Planning & Development Division
Planning & Economic Development Department

File Number	PL 23-038	Contact	Kyle Deming	
Type	Special Use Permit – Restaurant	Planning Commission Date		March 14, 2023
Deadline for Action	Application Date	February 17, 2023	60 Days	April 18, 2023
	Date Extension Letter Mailed	February 23, 2023	120 Days	June 17, 2023
Location of Subject	Southwest corner of Anderson Rd. and Central Entrance (Mall Area)			
Applicant	The Jigsaw, LLC	Contact	Dan Regan	
Agent	Kimley-Horn	Contact	Brian Wurdeman	
Legal Description	Lot 2, Block 1, Jigsaw Division			
Site Visit Date	March 3, 2023	Sign Notice Date	February 27, 2023	
Neighbor Letter Date	February 24, 2023	Number of Letters Sent	24

A Special Use Permit to allow two restaurants in the Jigsaw development at the southwest corner of Central Entrance and Anderson Rd. The project will consist of a 2,500 sq. ft. restaurant and a 660 sq. ft. drive-thru coffee kiosk and related parking and landscaping.

Recommended Action: Approve with conditions.

SHEET NUMBER
L1.1

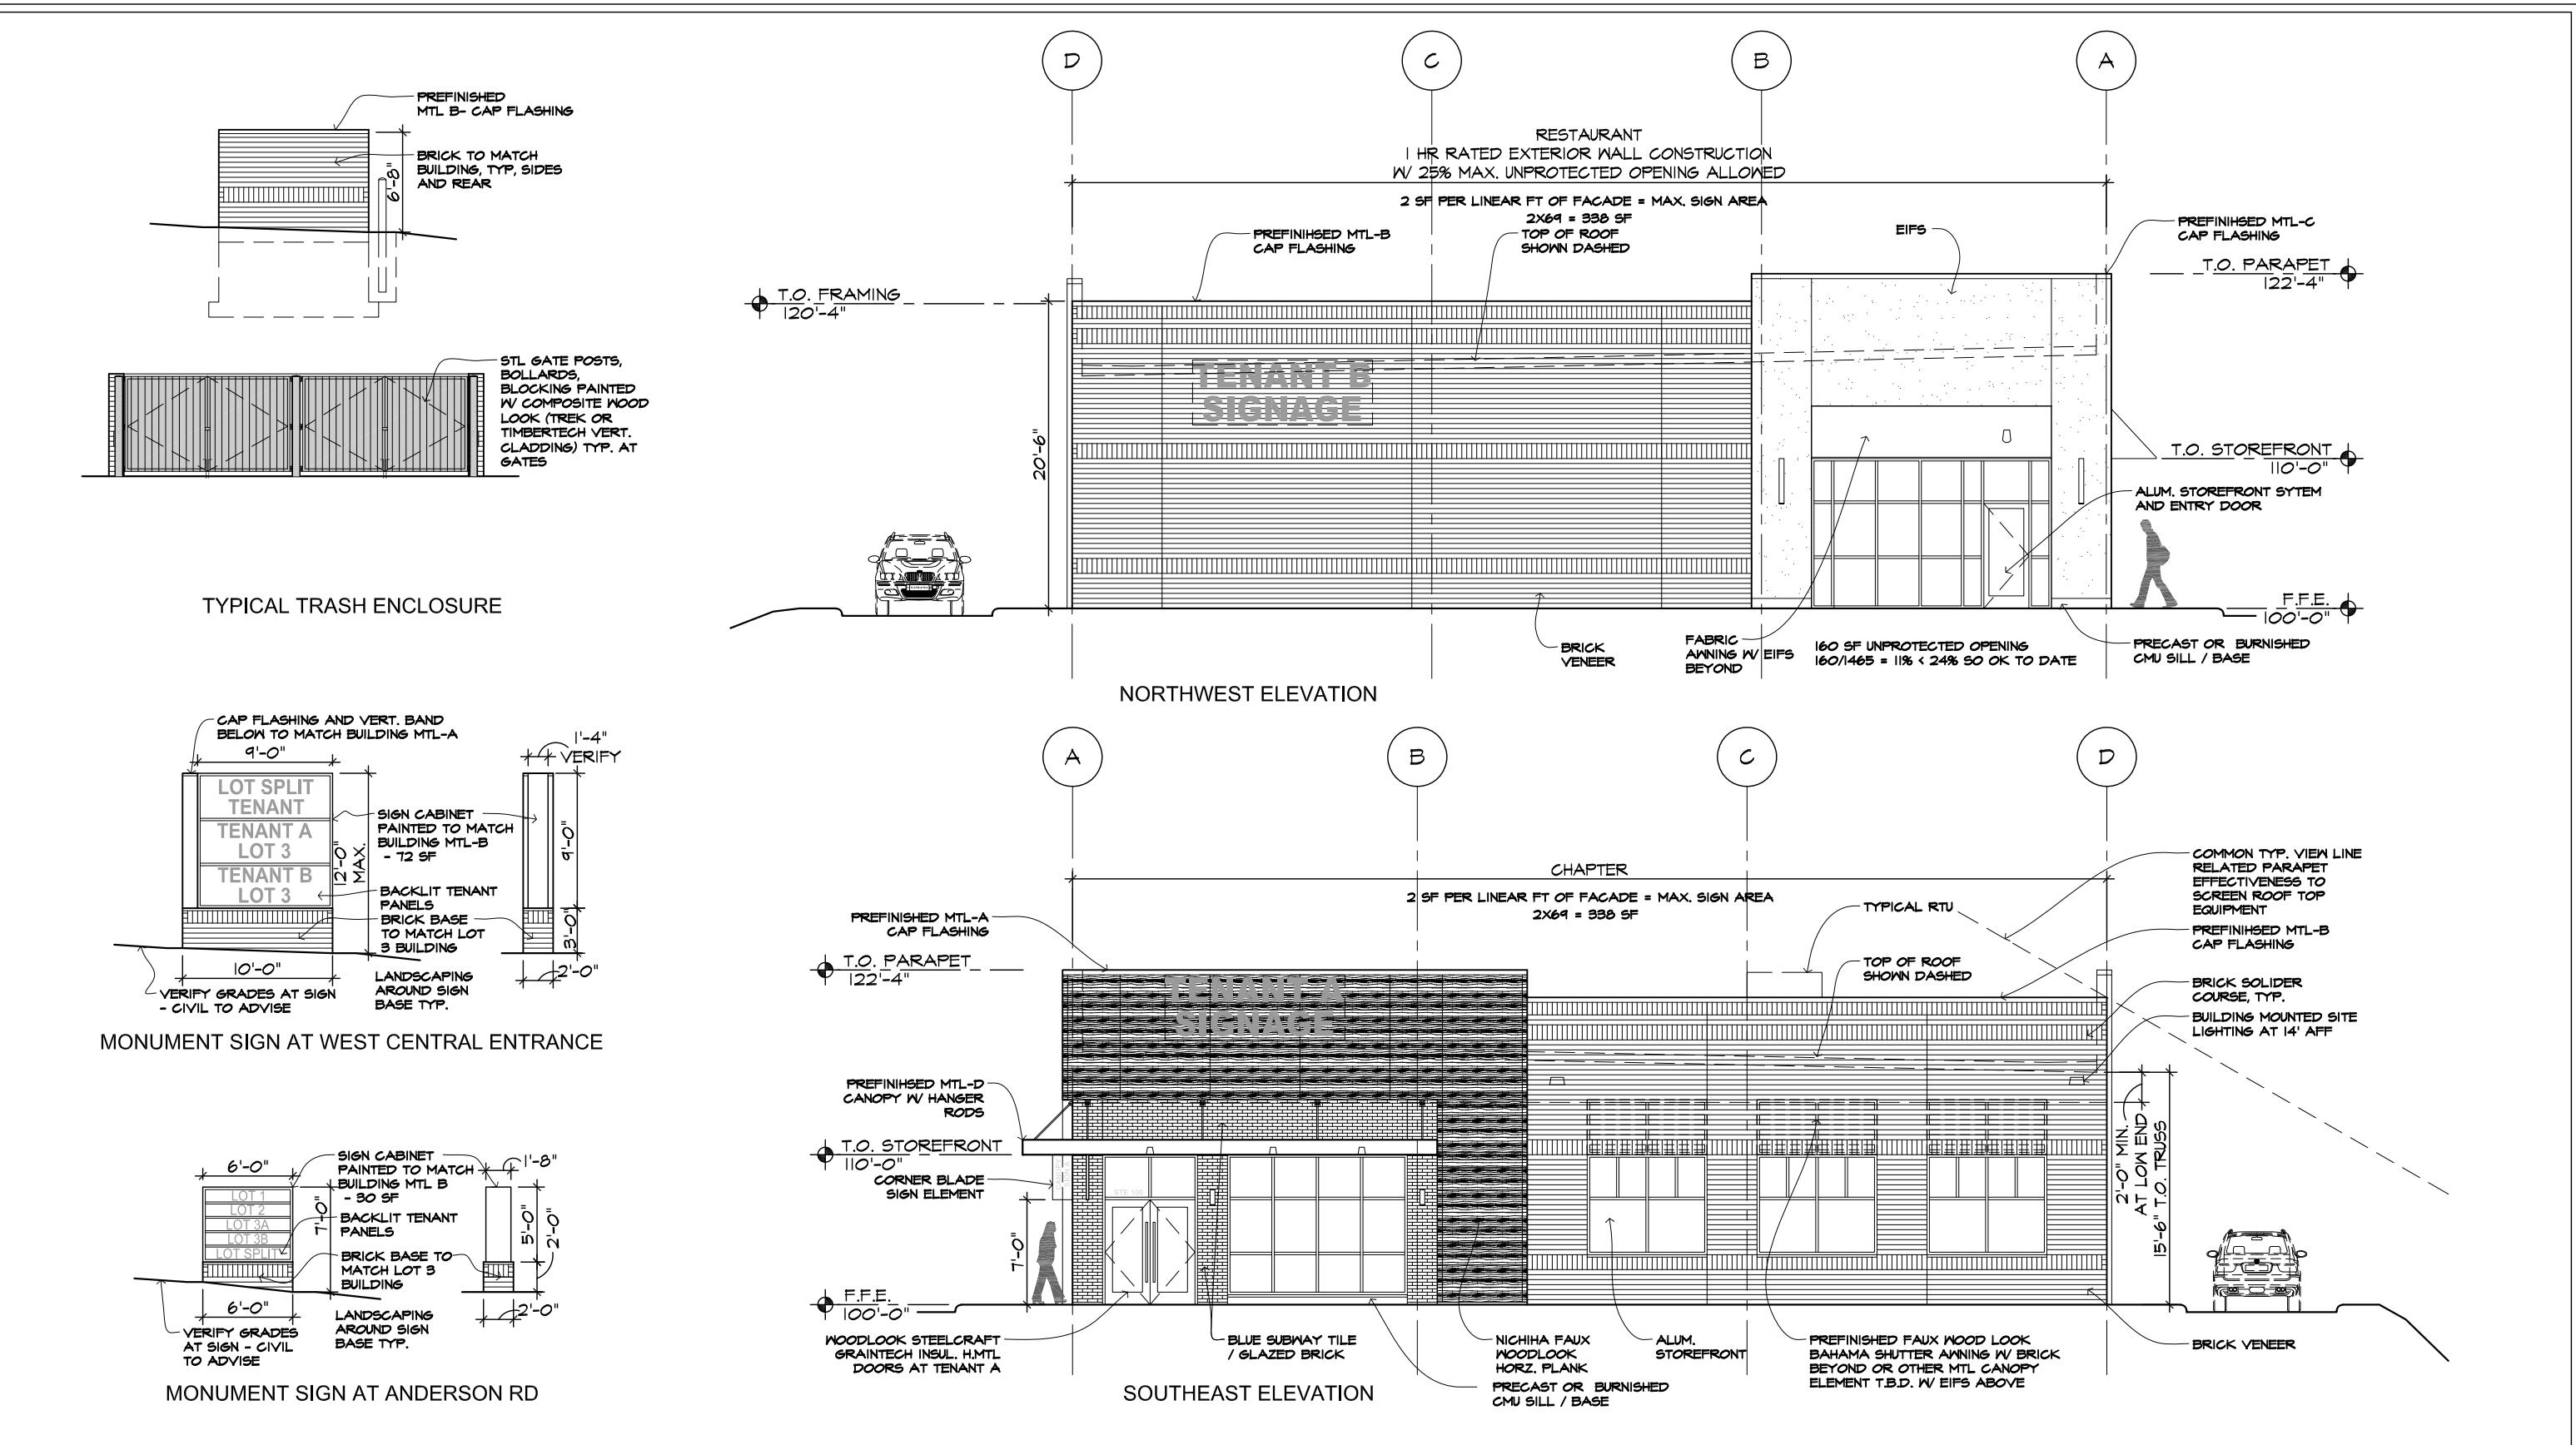
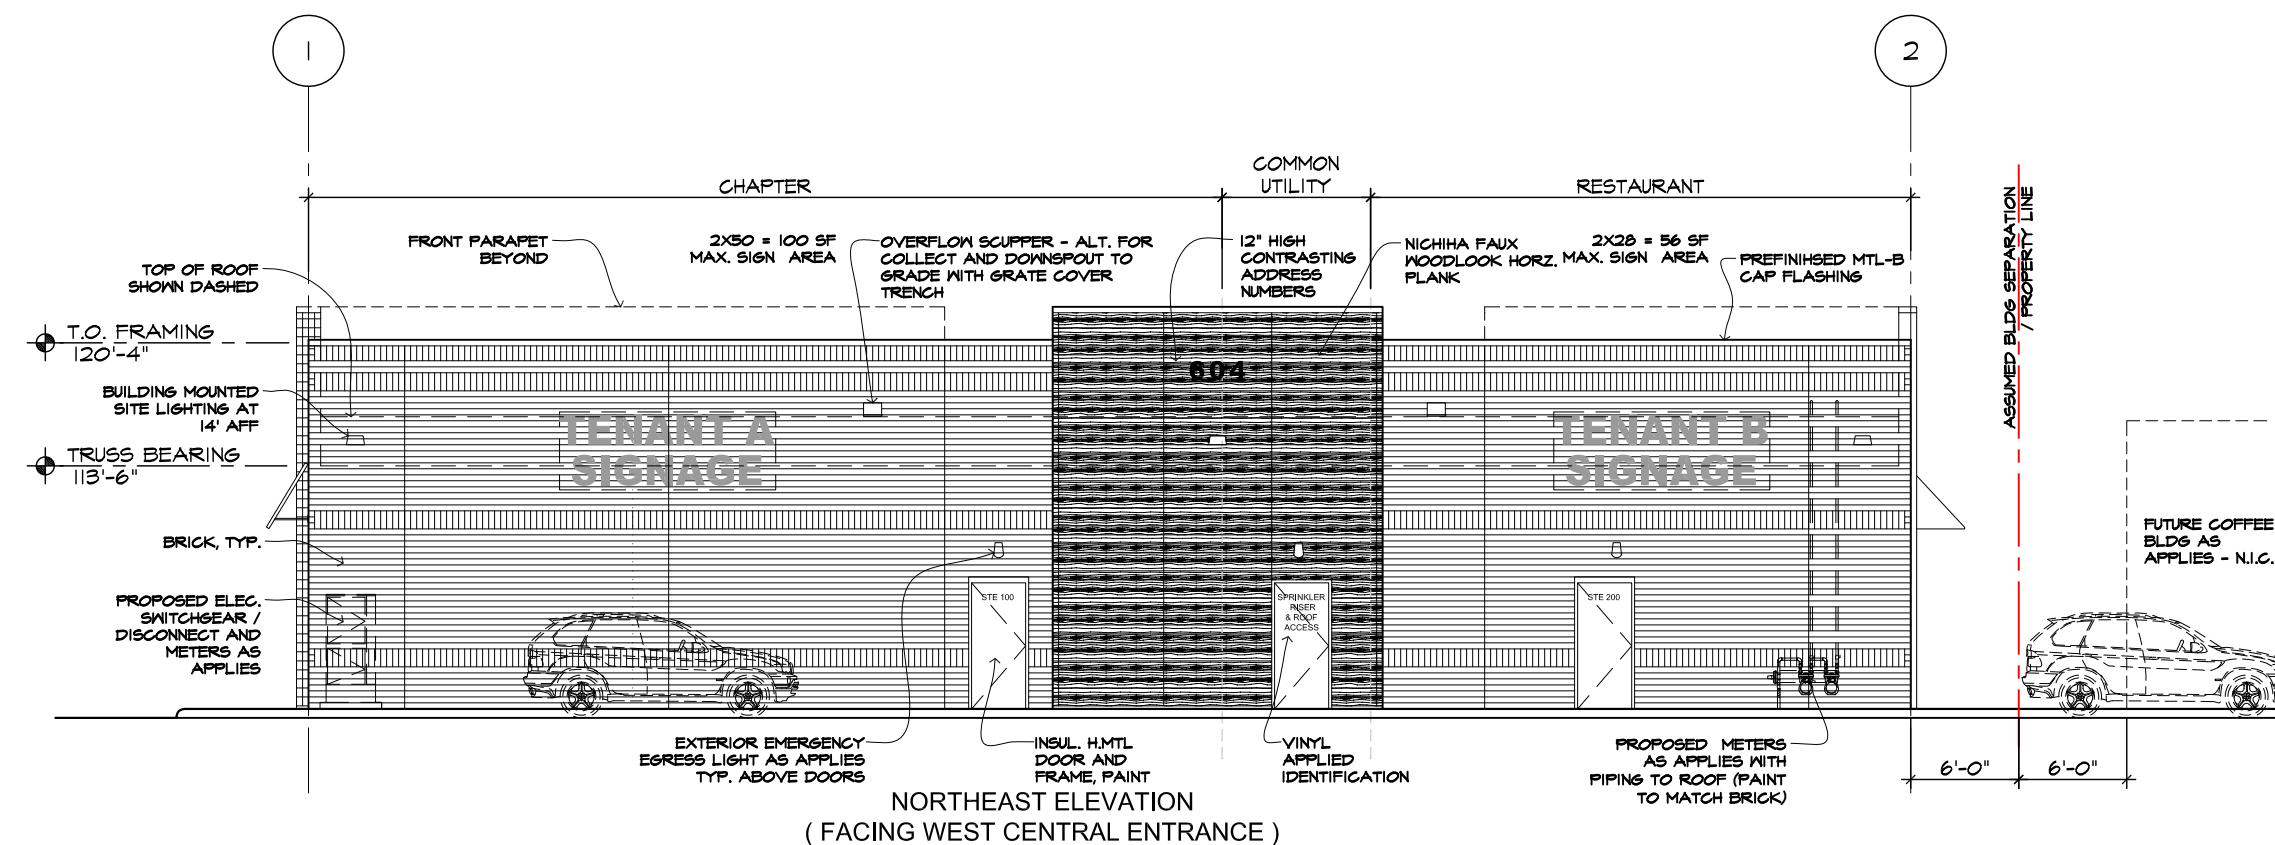
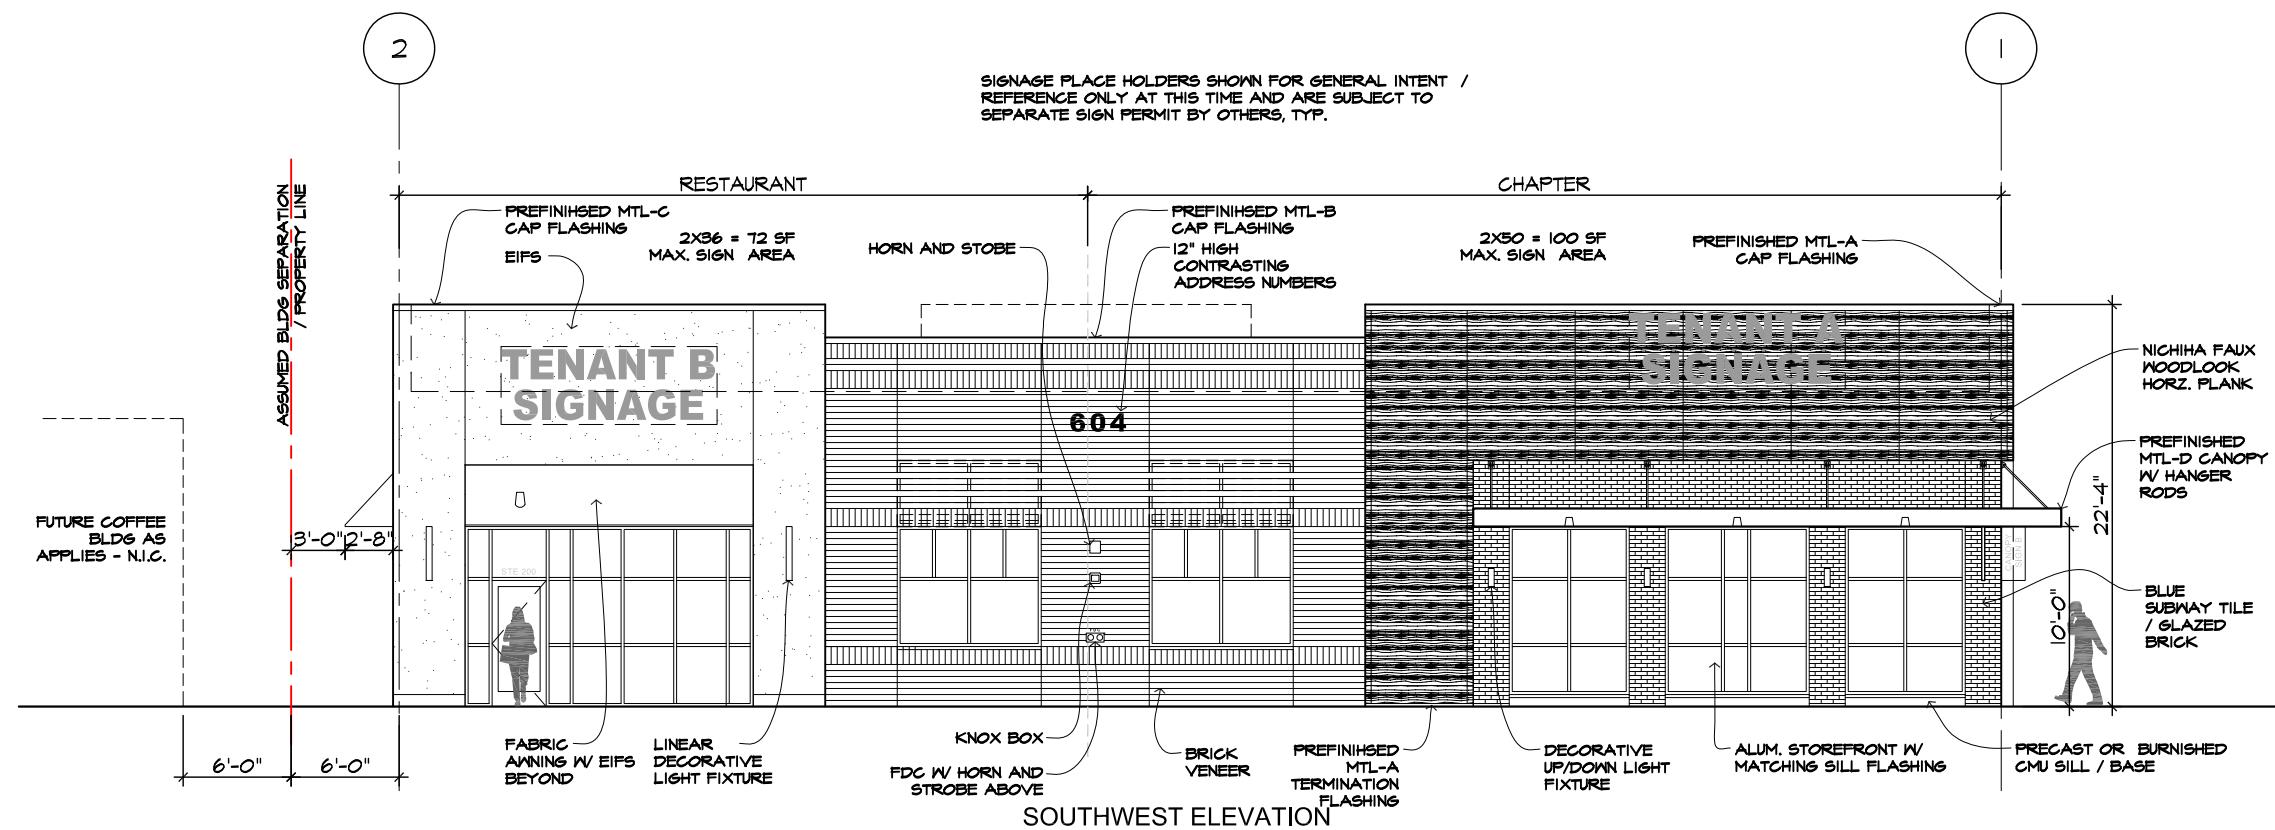
6. The landscape plan submitted does not provide enough trees along the Central Entrance frontage (8 are required, 3 are shown). This will need to be corrected before the building permit application.
